INSURVICE INSPECTION

ISO. NO: MCFI-INV-137
 DUKE PIPING CLASS: ASME SECT. III CL. A+B
 SYSTEM SYMBOL: CHEMICAL & VOLUME CONTROL
 PIPING SPEC: NV-19 PS1501.1, NV-21 PS1501.2
 DRAWING NO.: MC-141A-22.21-00, D1; 22-00, D1
 PROJECT: MCGUIRE

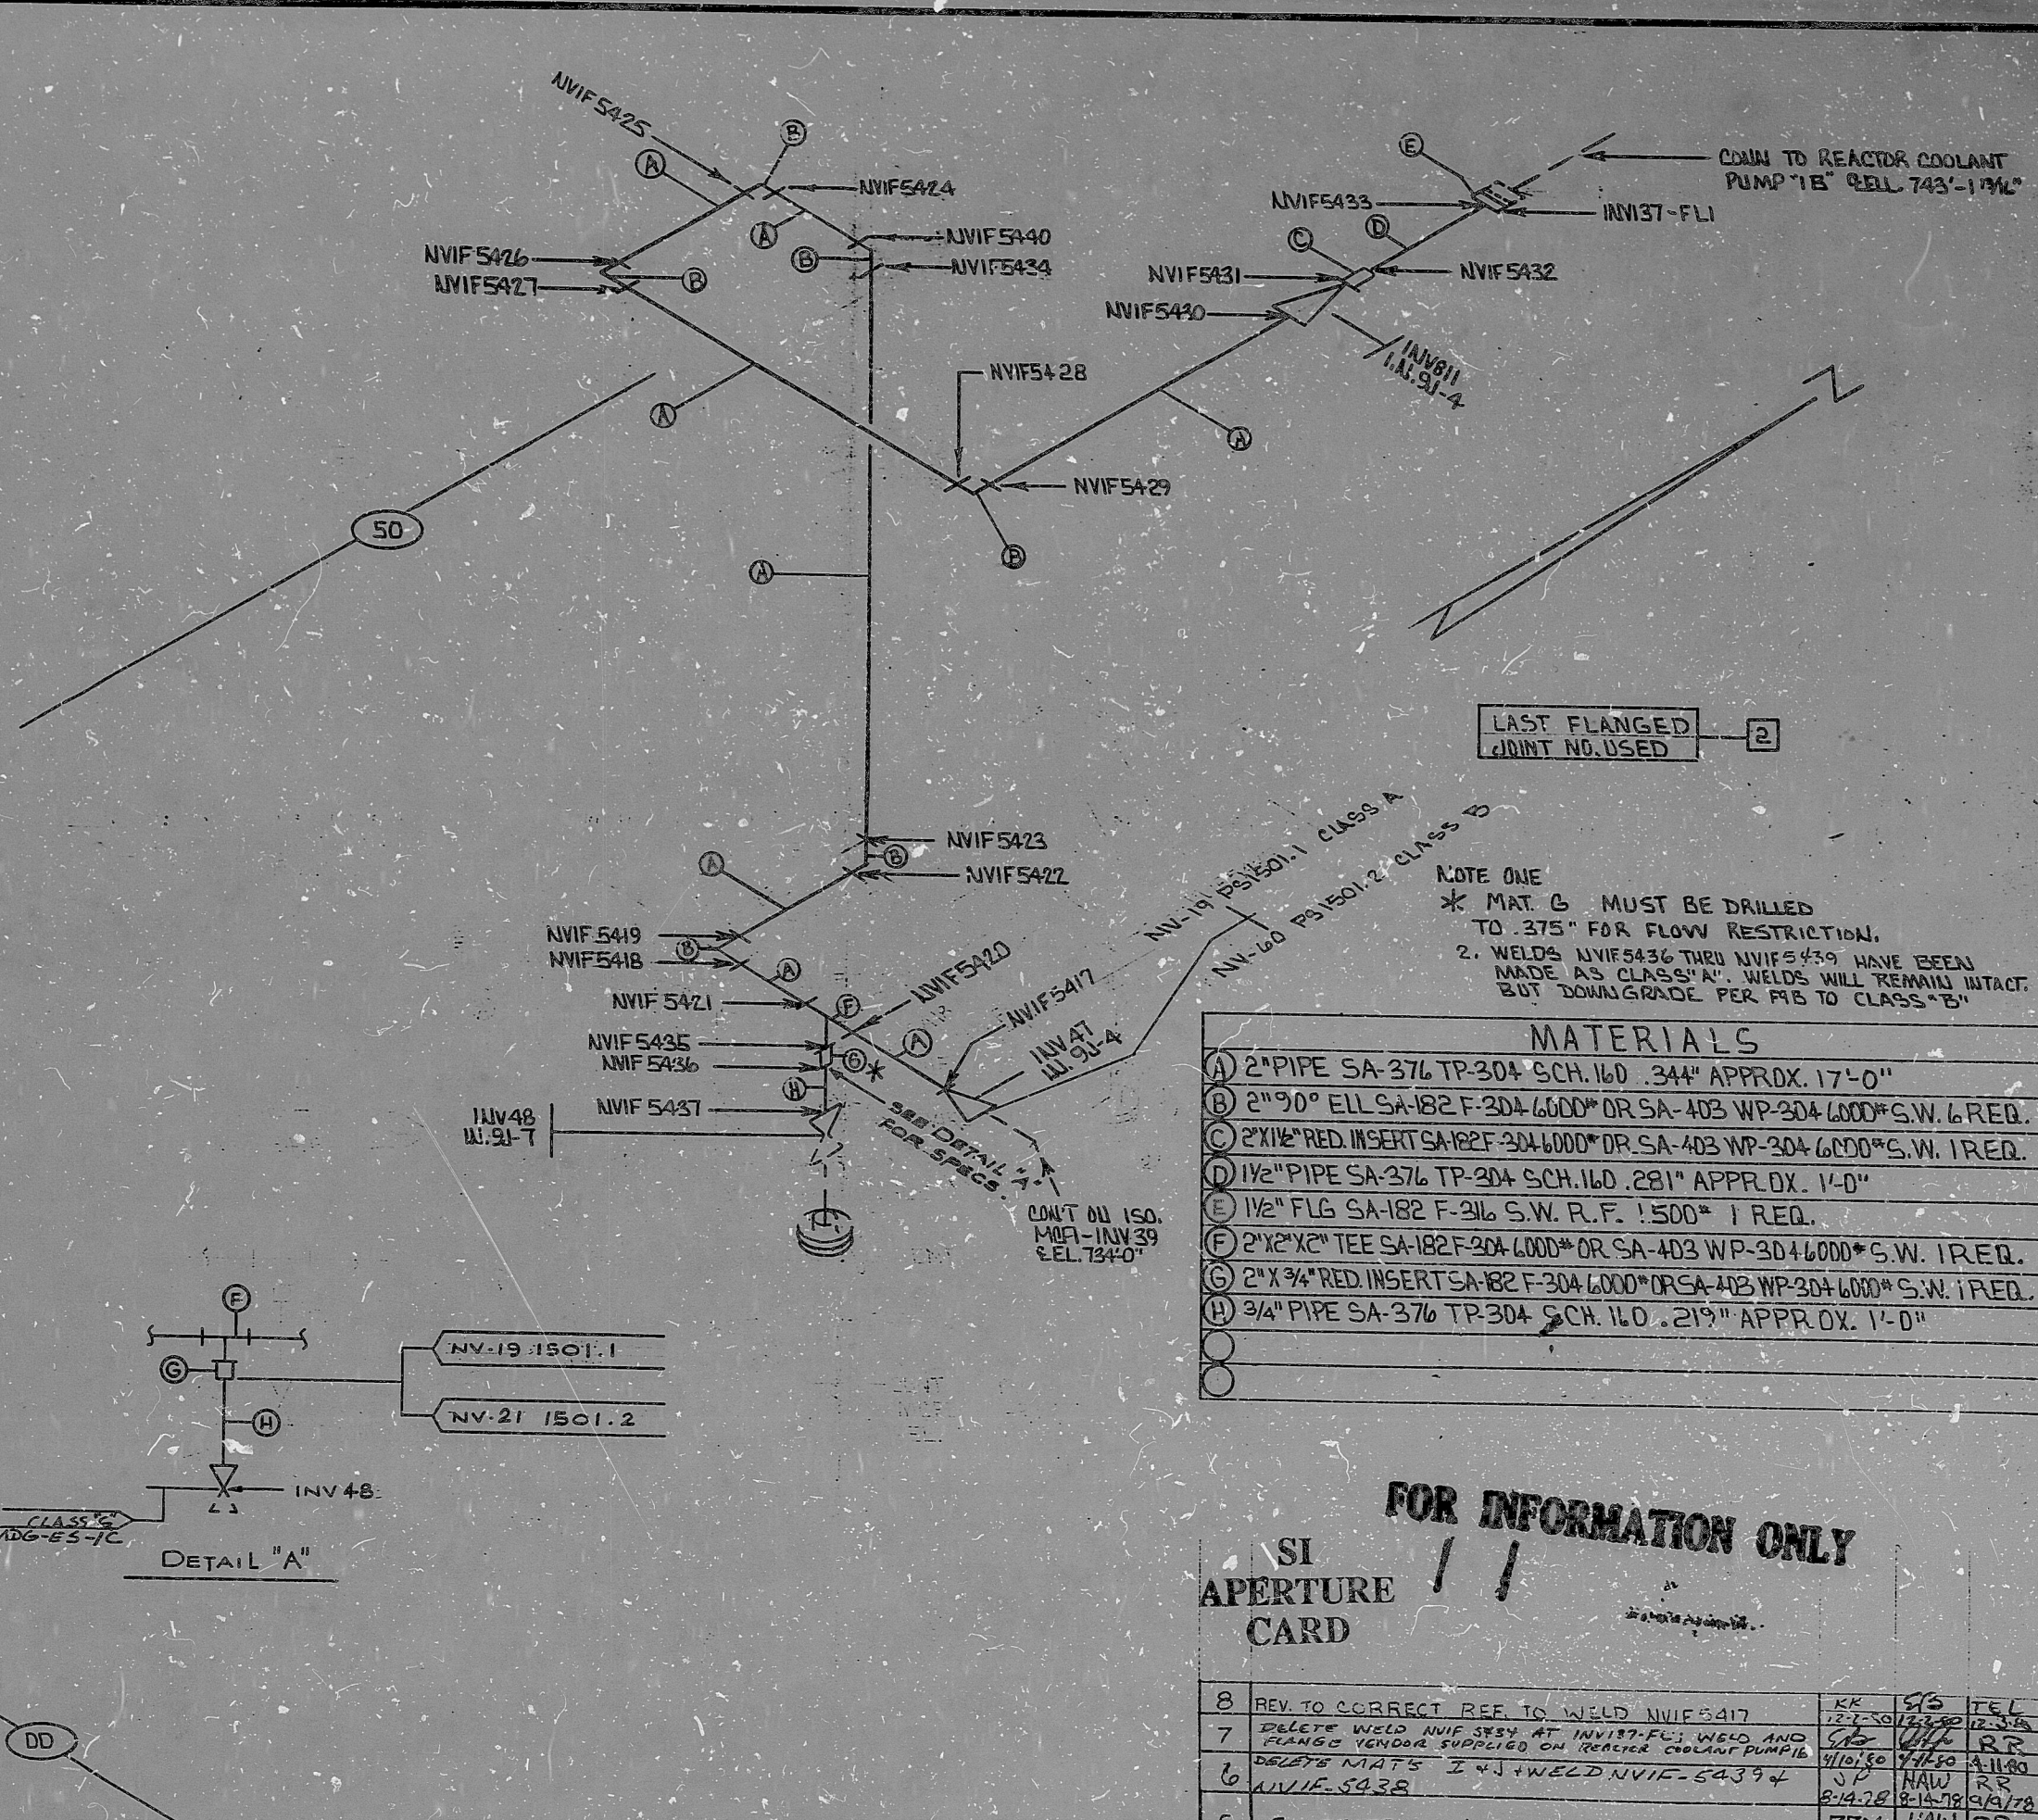
4	CHANGE SPEC IN DETAIL "A" TO IS01-2 + CHANGE MATS	11/18/78	12/20/78
3	FLOW DIAGRAM SECONDARY CHANGES - DOWNGRADED WELDS NOTE 2 & ADDED M-10A FOR INV137-2	10/17/78	12/14/78
2	REVISED TO SHOW SPEC. FLAGS AT DETAIL "A"	10/17/78	12/14/78
1	REVISED TO CHANGE CONFIGURATION IAW VII# 12188	10/17/78	12/14/78
D	REL. FOR CONST.	10/17/78	12/14/78
NO.	REVISION	ORIG. CHGD. APPR.	DATE DATE DATE

8	REV. TO CORRECT REF. TO WELD NVIF5417	KK	SYS	TEL
7	DELETE WELD NVIF 5434 AT INV137-FL1; WELD AND FLANGE VENDOR SUPPLIED ON REACTOR COOLANT PUMP 1B	12-7-80	12-7-80	12-7-80
6	DELETE MATS I & J + WELD NVIF-5439 + NVIF-5438	11/10/80	11/10/80	11/10/80
5	CORRECTED VALVE NO. IN DETAIL "A"	12/14/78	12/14/78	12/14/78
